PROJECT:
Green Meadow Elementary School -
Early Site Package
5 Tiger Drive
Maynard, MA 01754
Project No.

ADDENDUM NO. 1 06/07/2024

ADDENDUM NO. 1
to the Contract Documents Bid Set dated May 22, 2024

GREEN MEADOW ELEMETARY SCHOOL PROJECT
EARLY SITE BID PACKAGE
Maynard, Massachusetts

DRAWING NUMBER
C-02.3

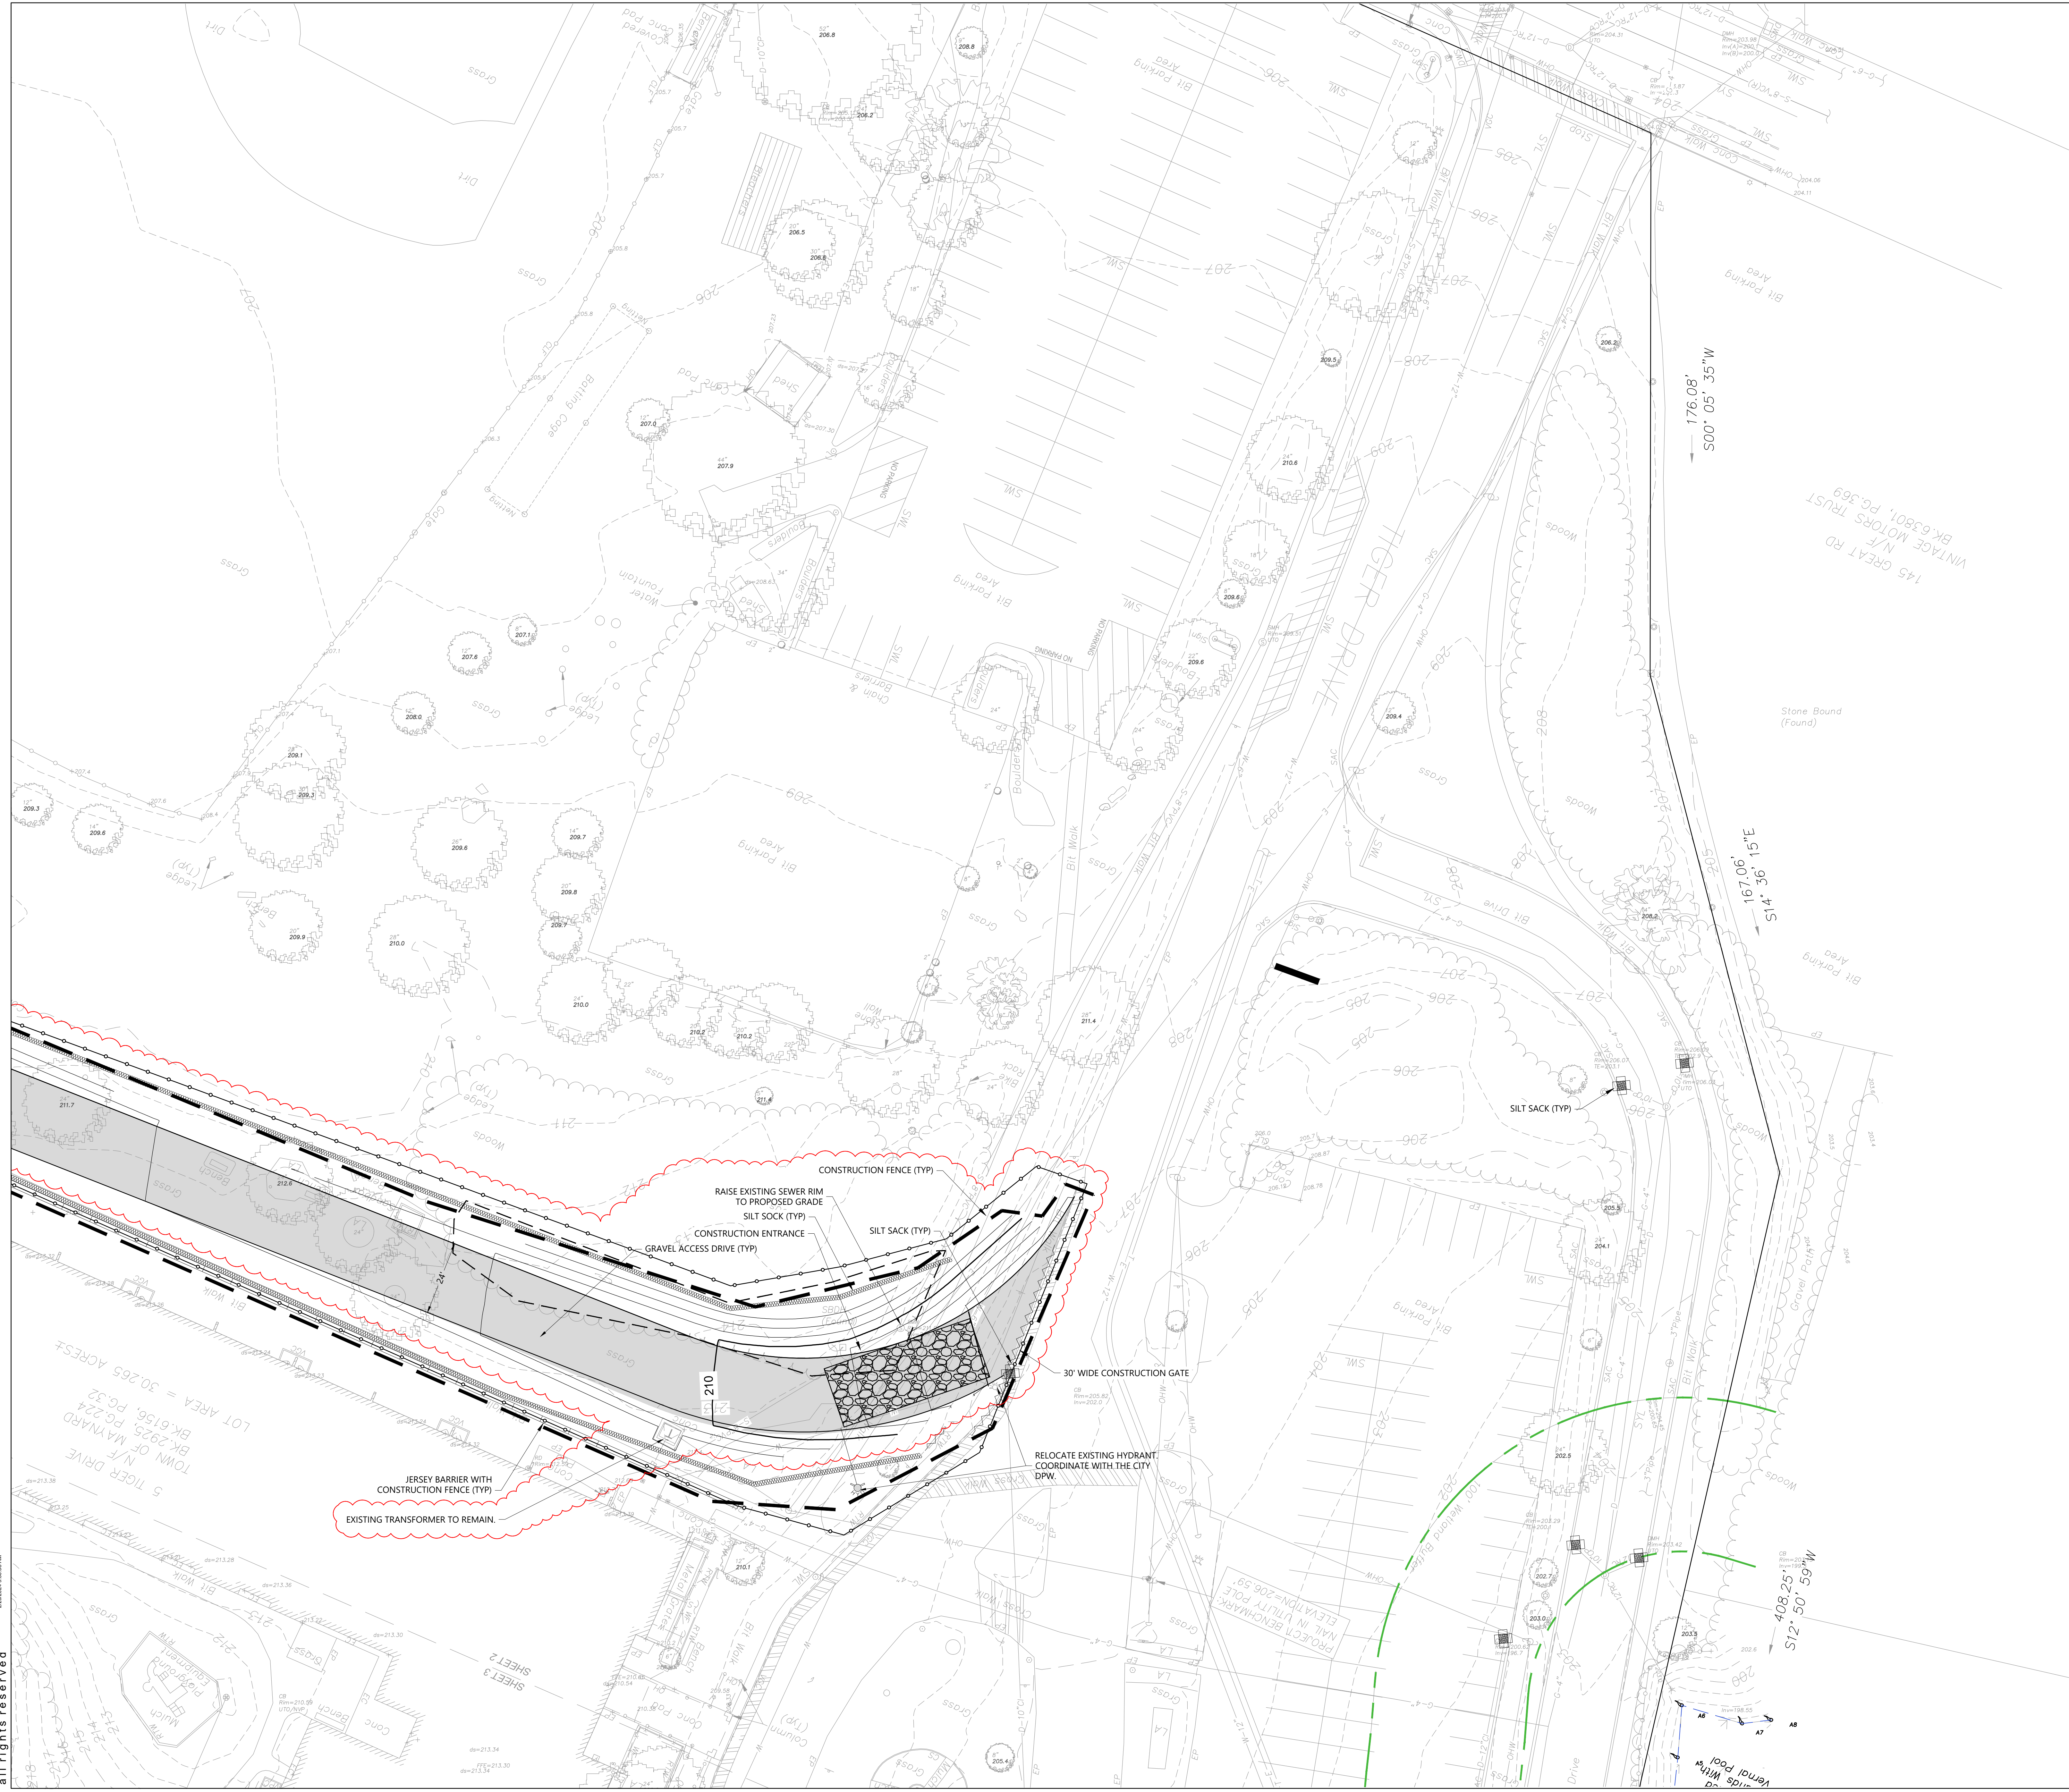
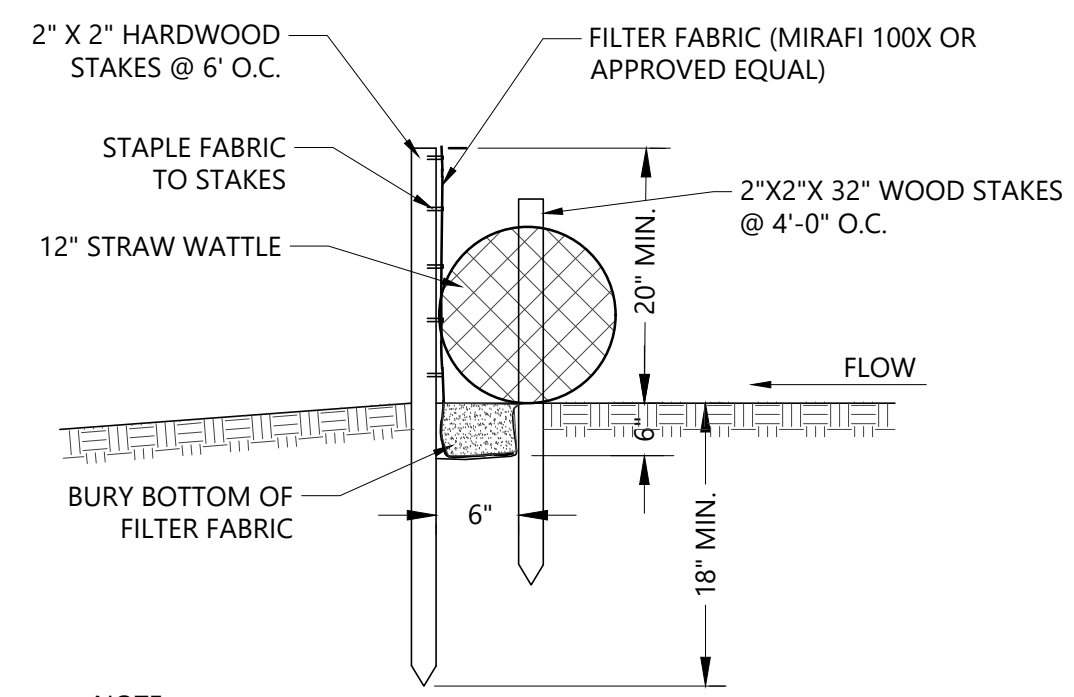
The specs refer to relocating the existing transformer, but the drawings indicate that it is to be removed. If relocated, what work is required? Is there a proposed location? Will a new transformer be installed prior to removal of the existing?

DRAWING C-02.3 – SITE PREPARATION PLAN

ITEM 01: Revised Limit of work, construction fence and silt sock layout

ITEM 02: Existing transformer to remain

ITEM 03: Revised access drive layout

The existing transformer will remain as is, see addendum 01 for narrative, specification and drawing clarifications.

DETAIL @ CHAIN LINK FENCE
NOT TO SCALE

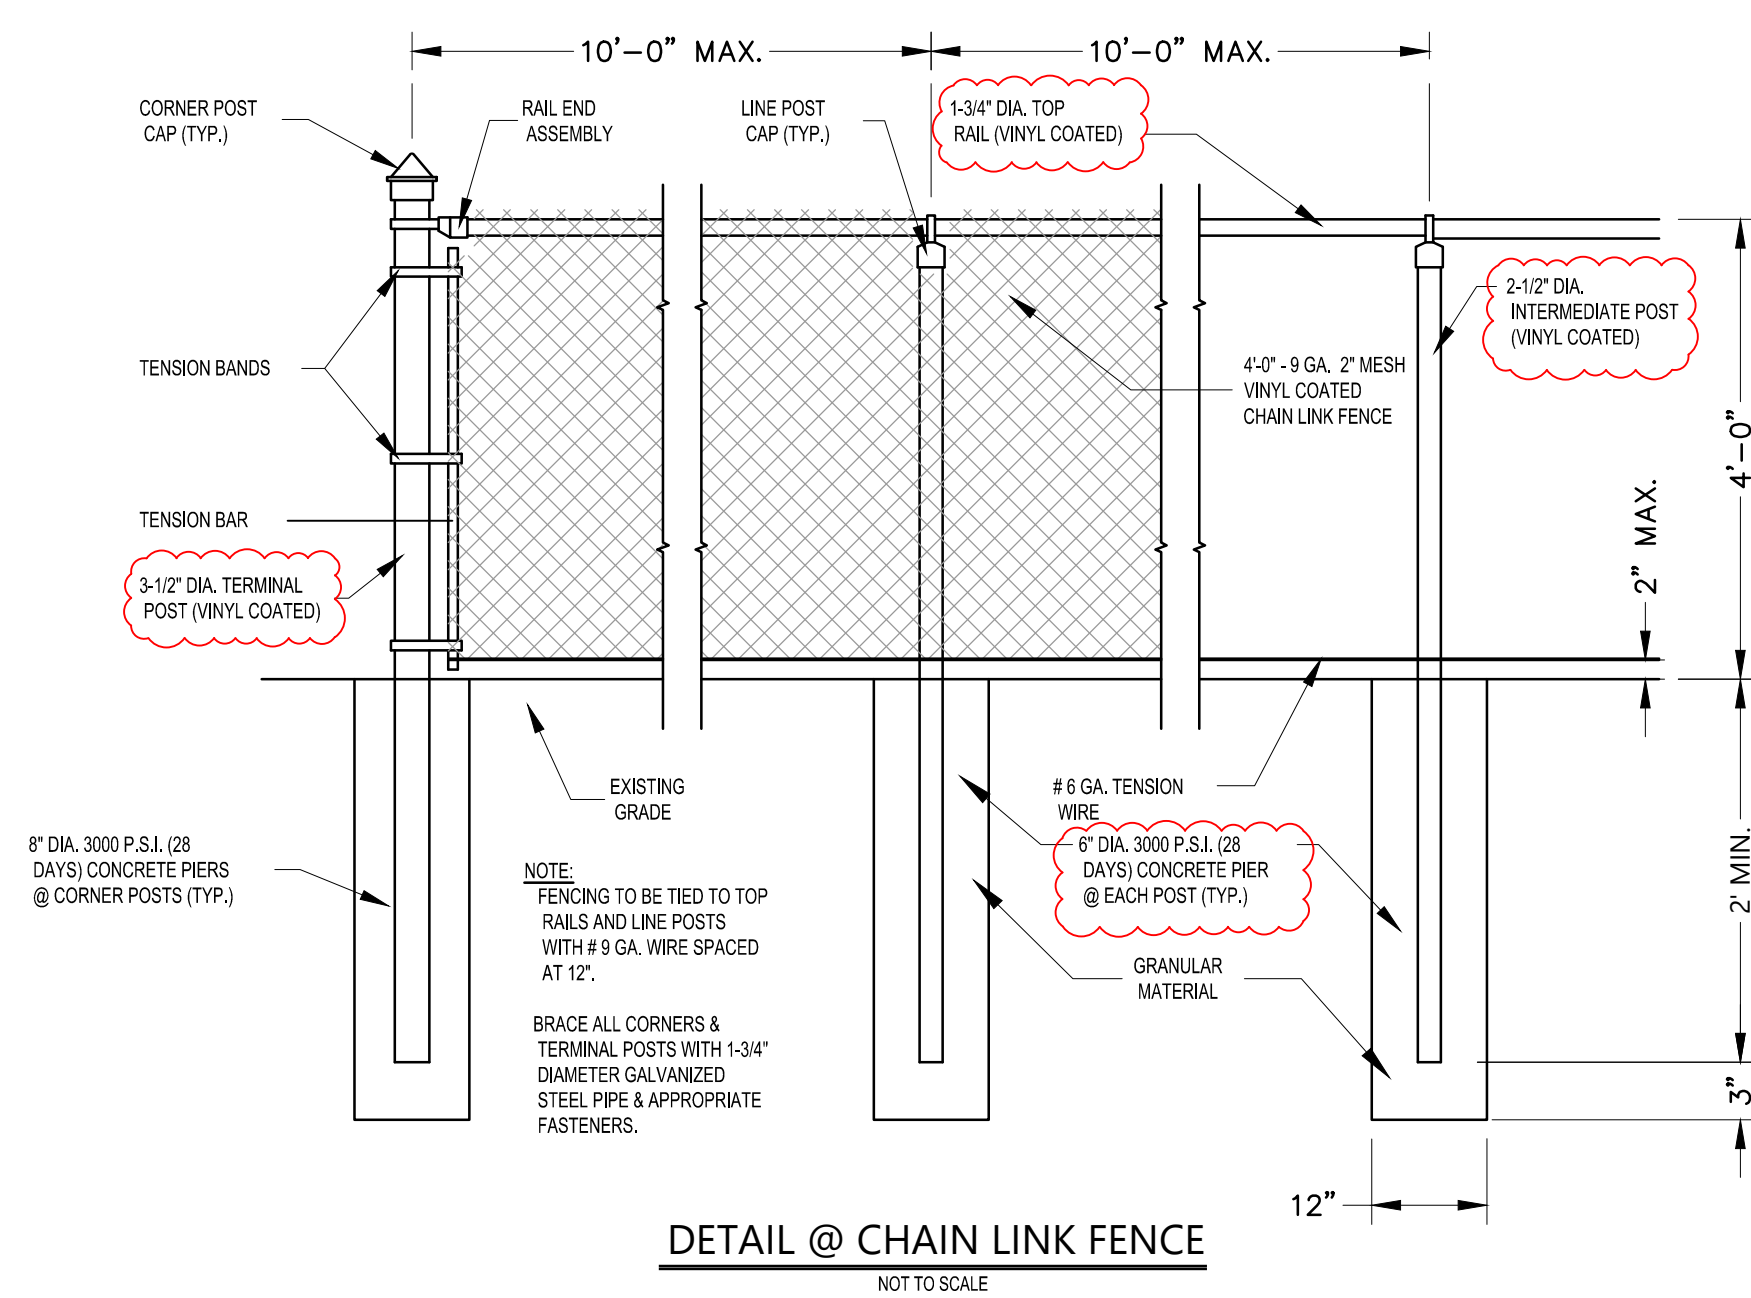
Regarding the 4' CLF: The plans call out vinyl ctd fabric and galvanized post. Typically the framework and fabric match. Please confirm if the fence is galv or vinyl ctd. There are 2 different psi requirements for the concrete fence posts foundations. Please confirm either 5000 psi, which is excessive, or 3000 psi, which is more typical.

ITEM 01: Revised chain link fence detail – posts to be vinyl coated
